Subject: P.H.O. APPLICATION NO. PHO-1-26--Z-29-23-7(8) – Notice of Pending Actions by the Planning Hearing Officer

APPLICATION NO: PHO-1-26--Z-29-23-7(8)

Request For: Stipulation Modification

Property Location: Approximately 300 feet east of the northeast corner of 43rd Avenue and Baseline Road

lot 4 conceptual elevations

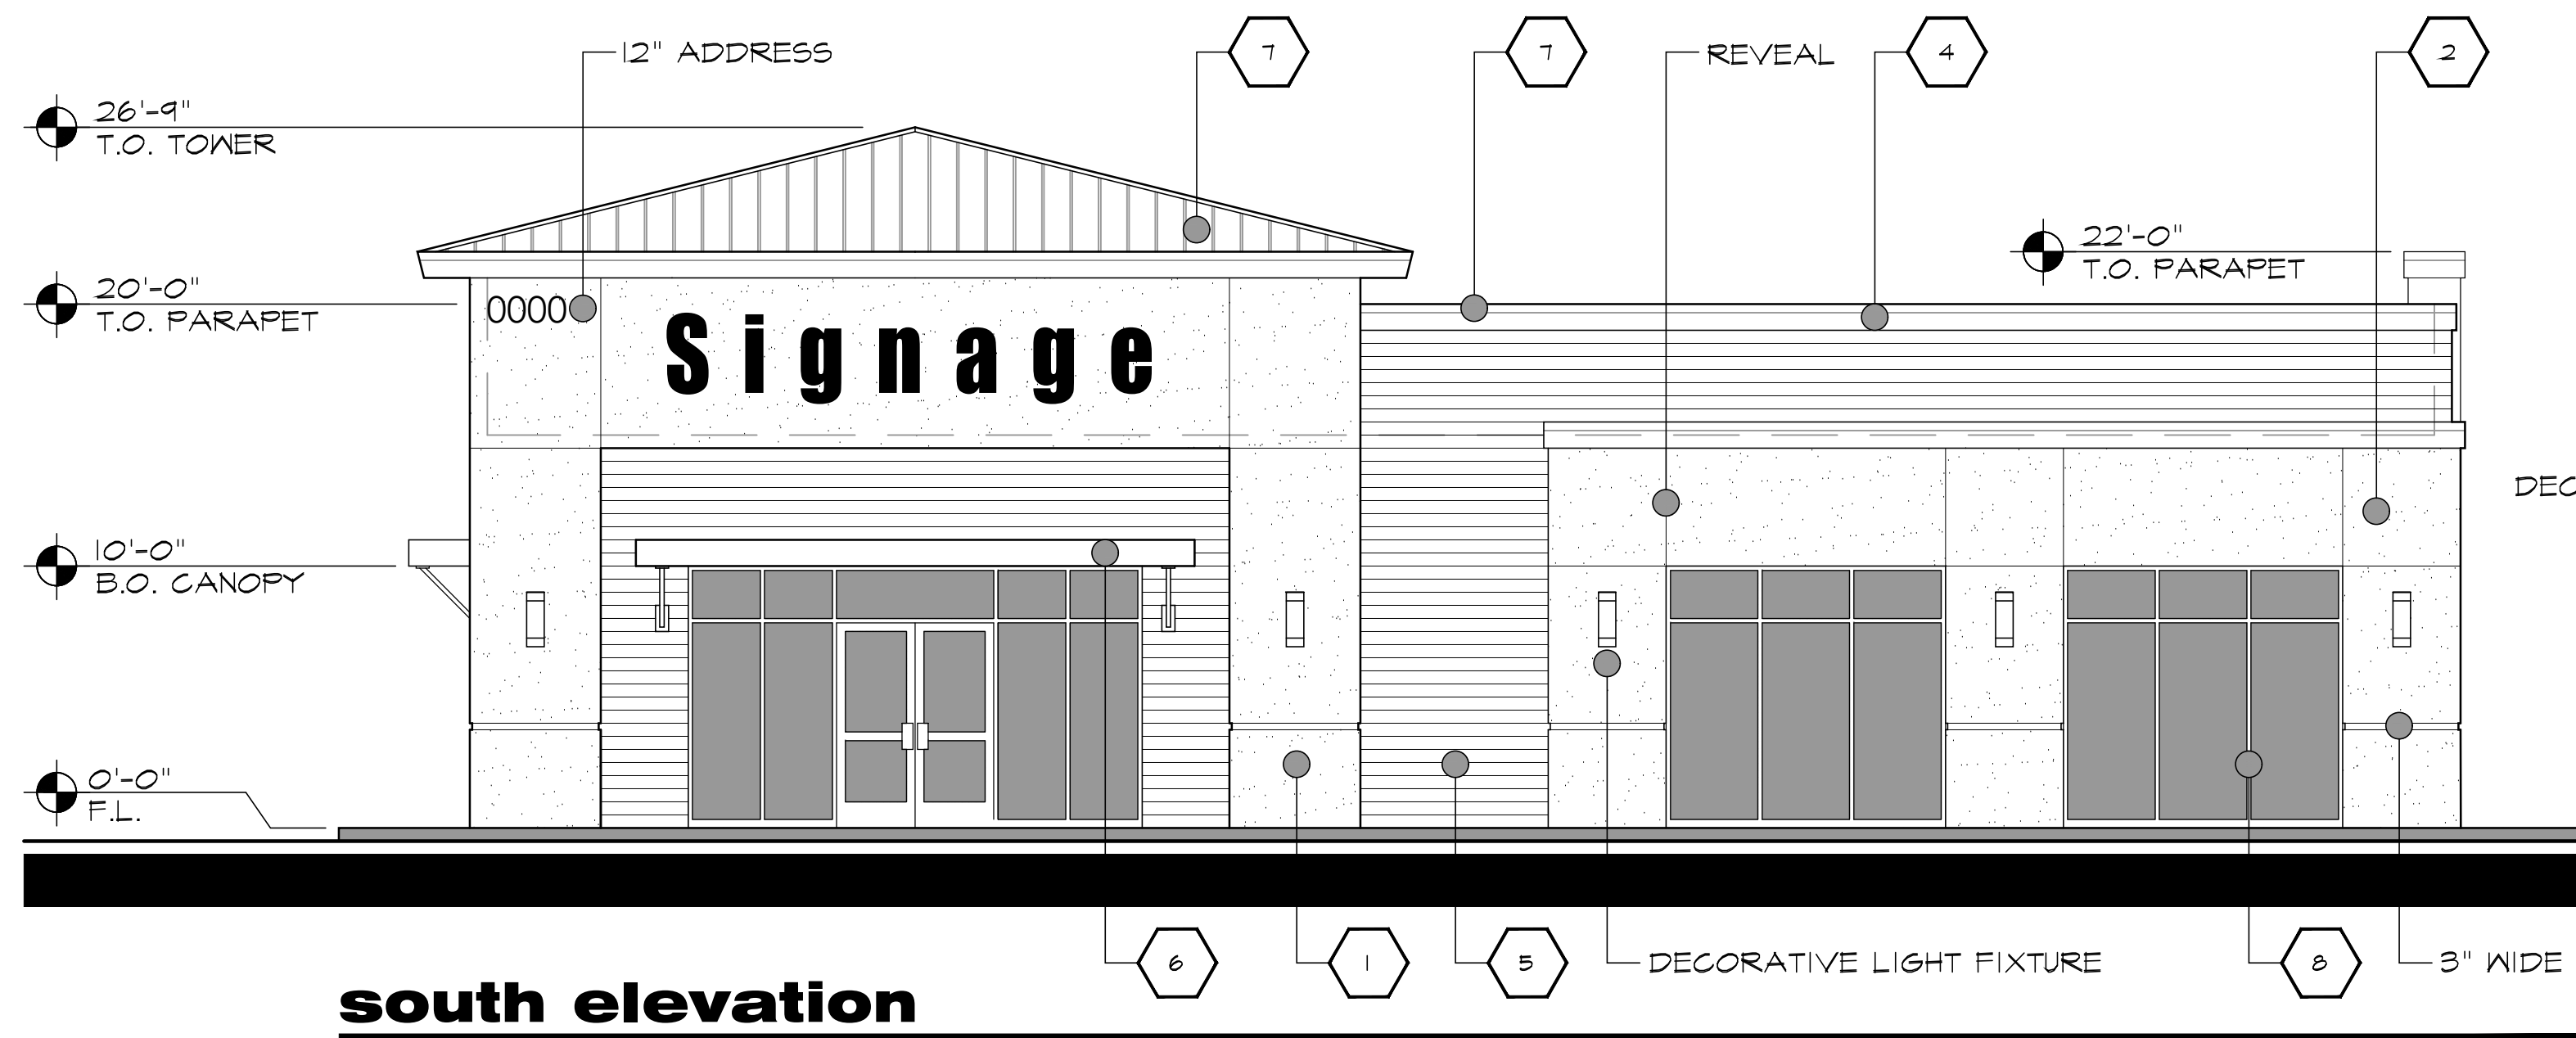
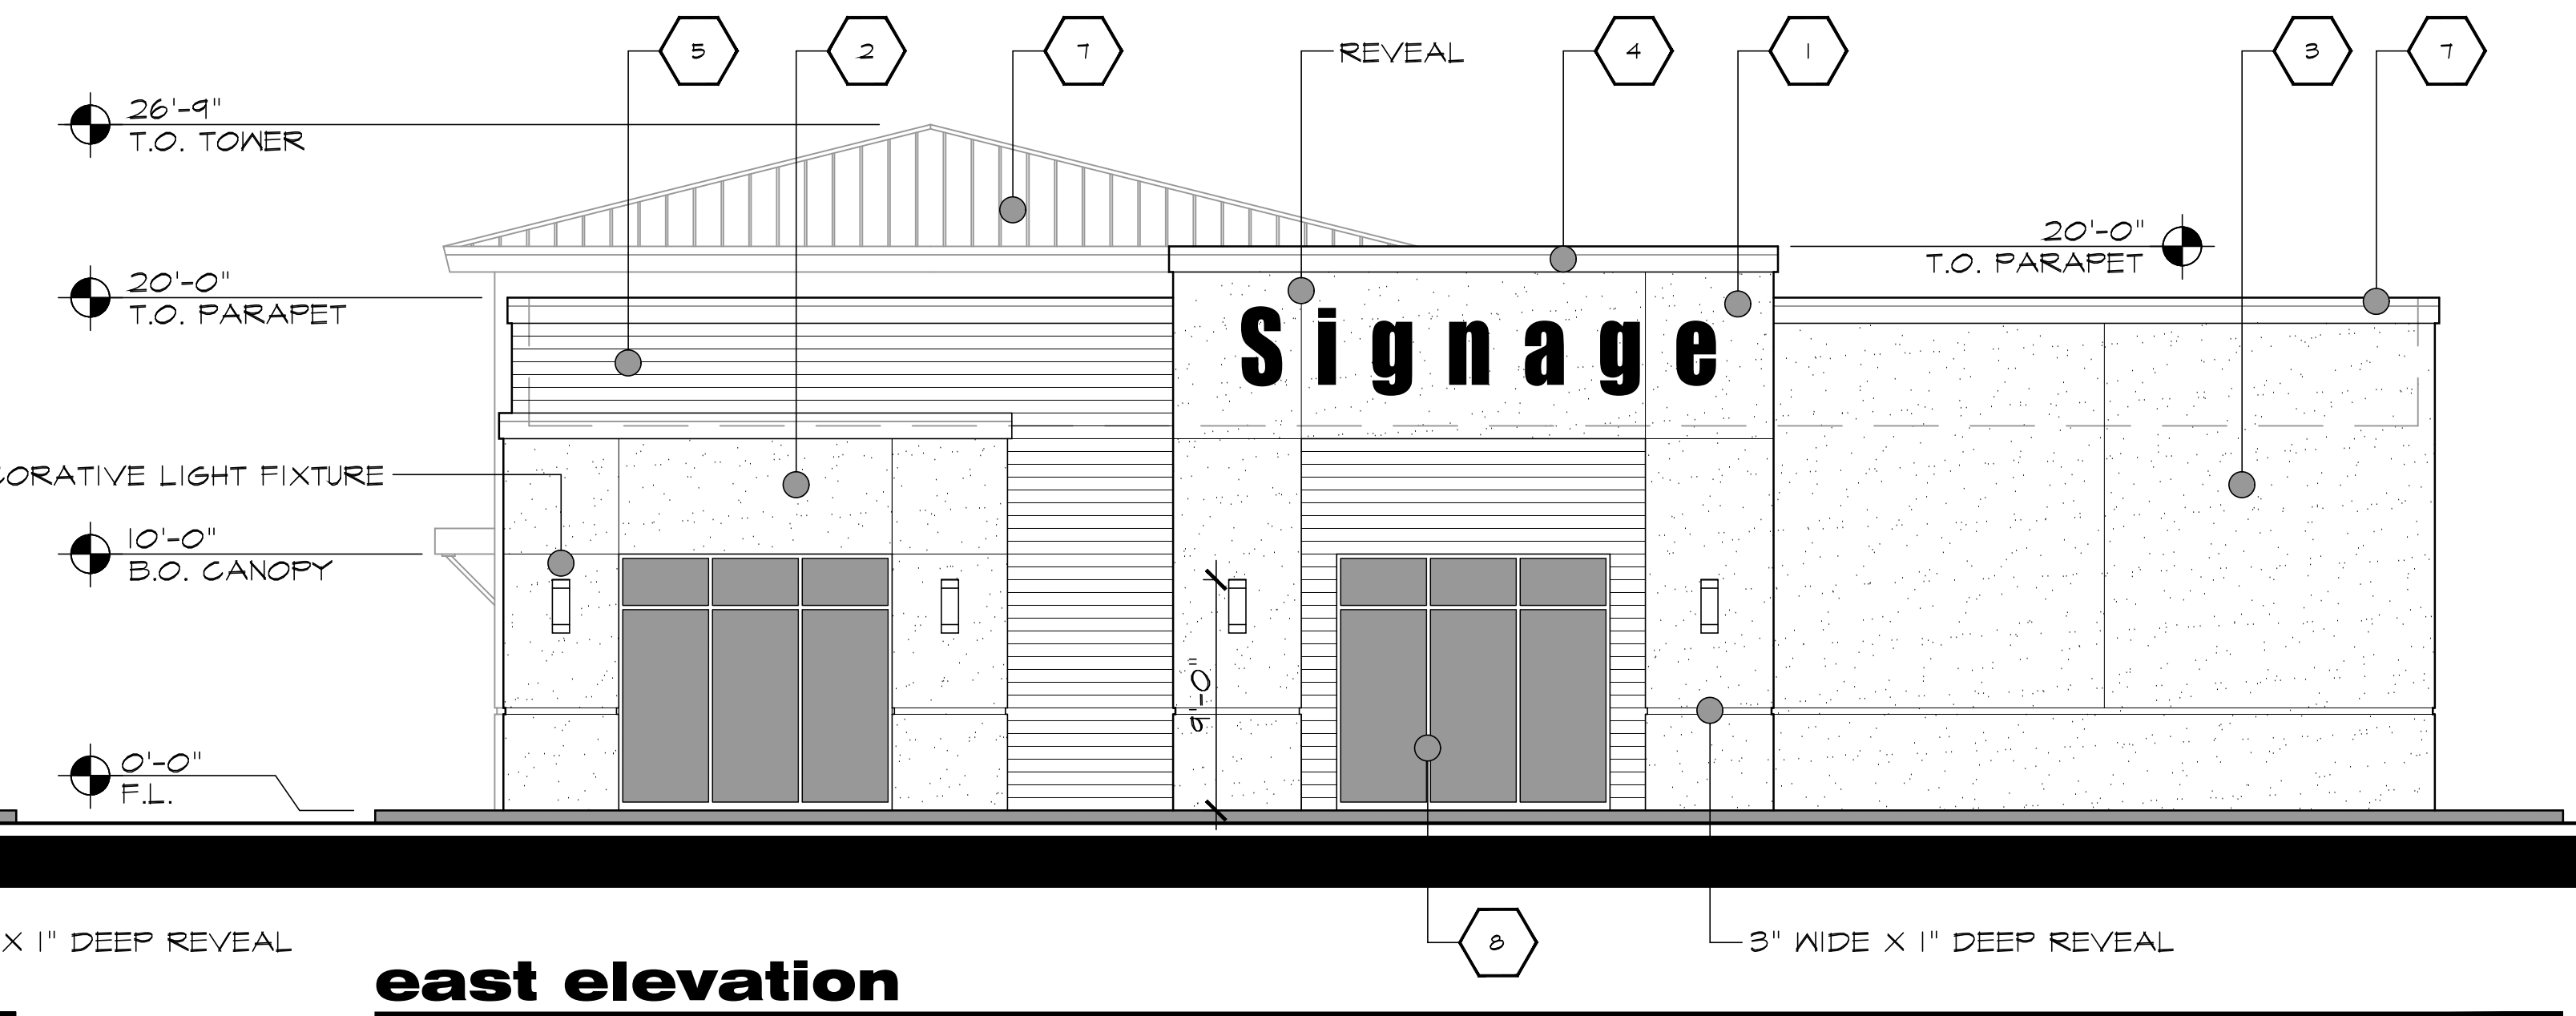
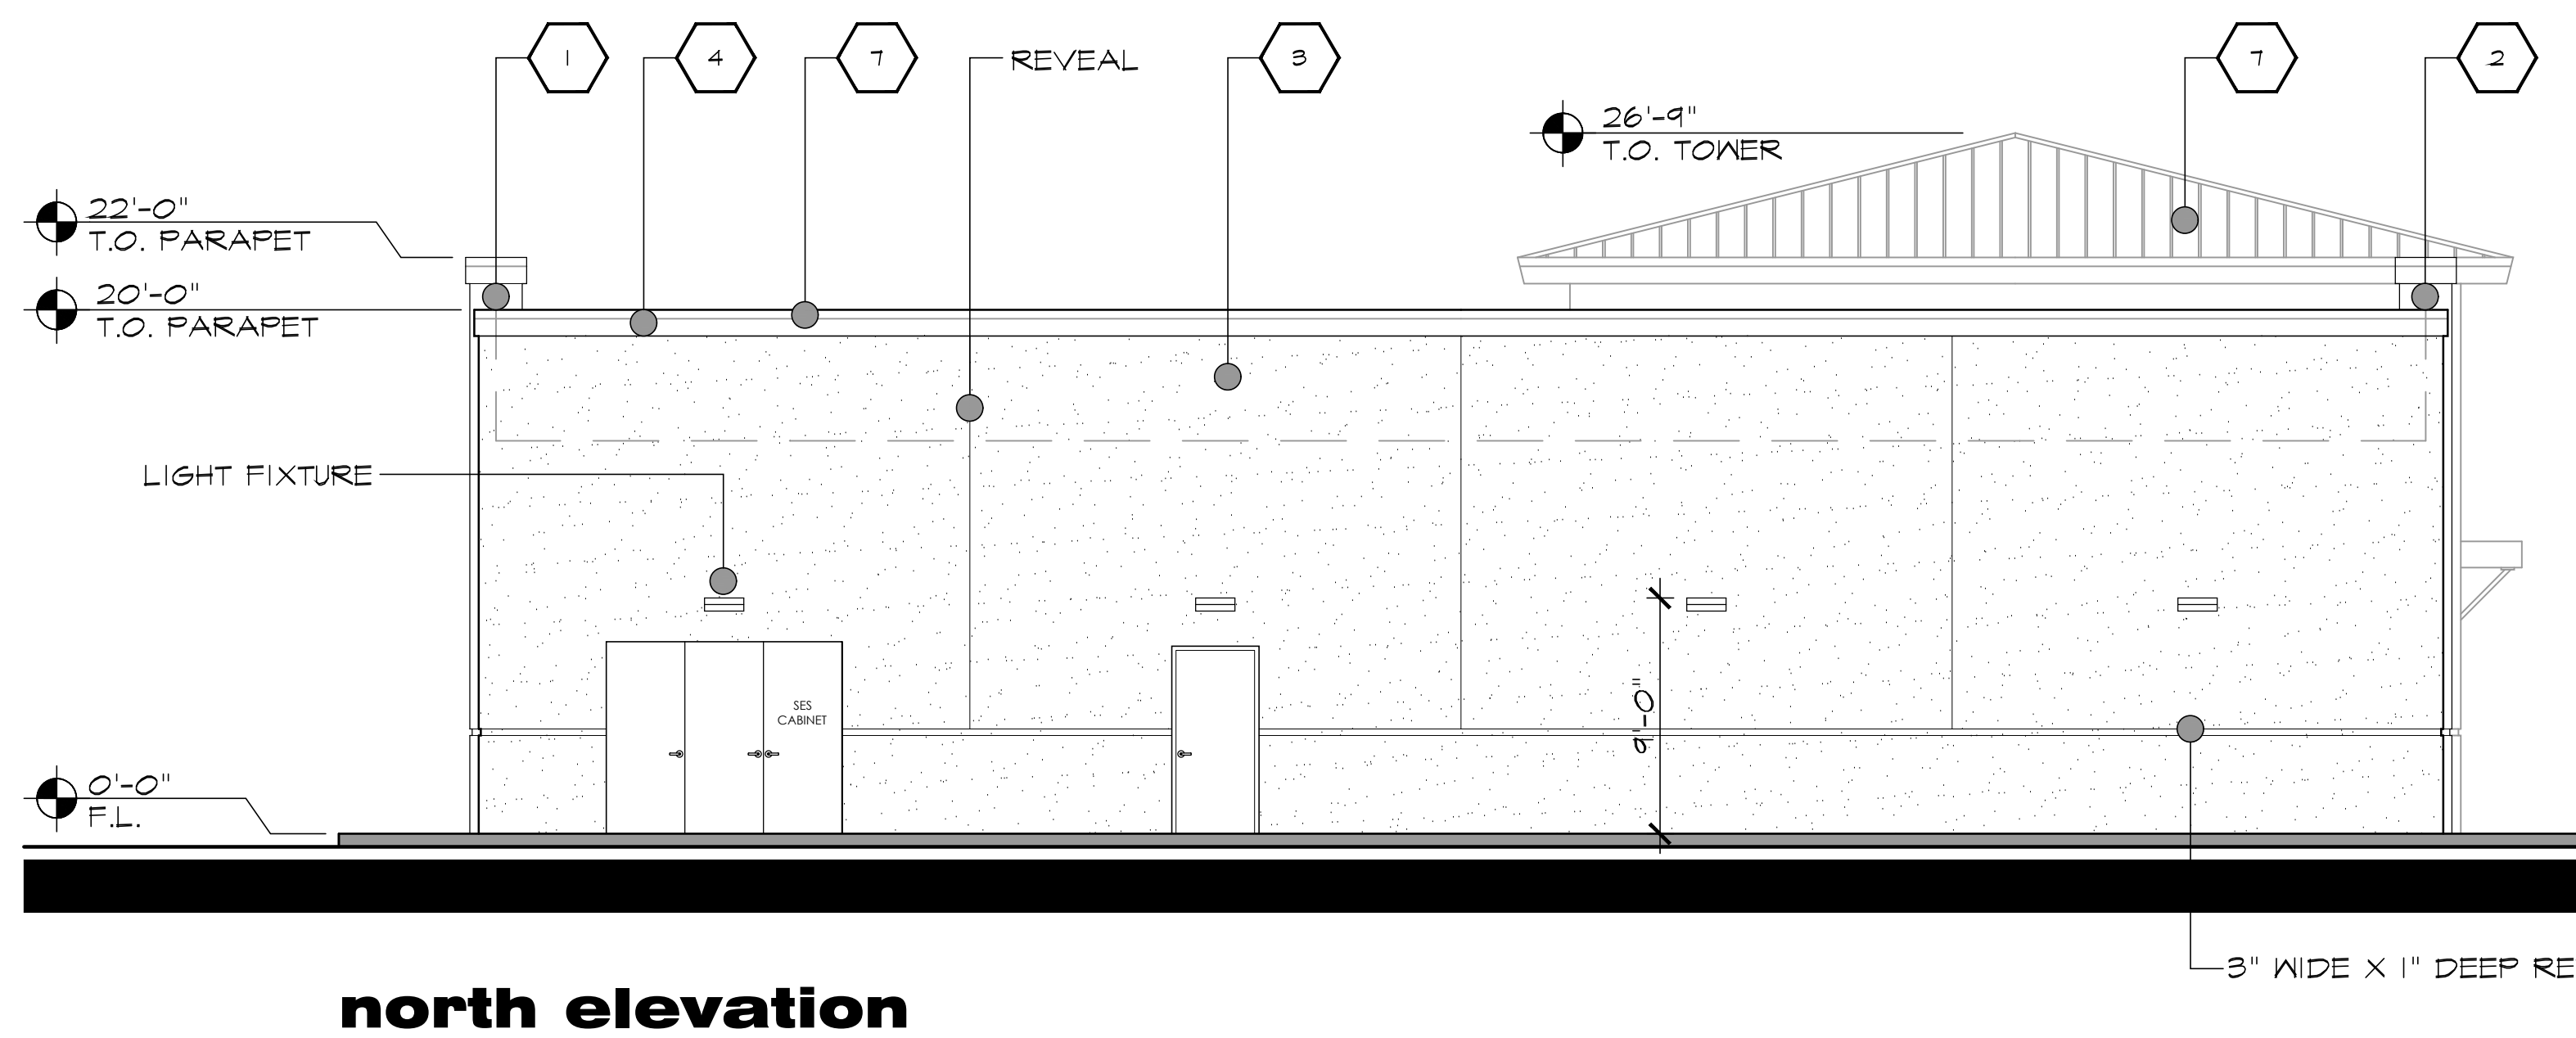
[Lot 4 Site Plan and Elevations](#)

The site plan for Lot 4 is proposed to contain a 5,625 square foot structure and ancillary surface parking. The structure is oriented towards Baseline Road to create an inviting street presence. To reduce visibility from Baseline road, the trash enclosure and loading area serving the future commercial business are located at the rear of the structure. Two bicycle racks capable of holding 4 bicycles are provided along the front of the structure. Pedestrian connectivity from Lot 4 is provided via ADA accessible paths and includes connections to the multi-use trail along Baseline Road.
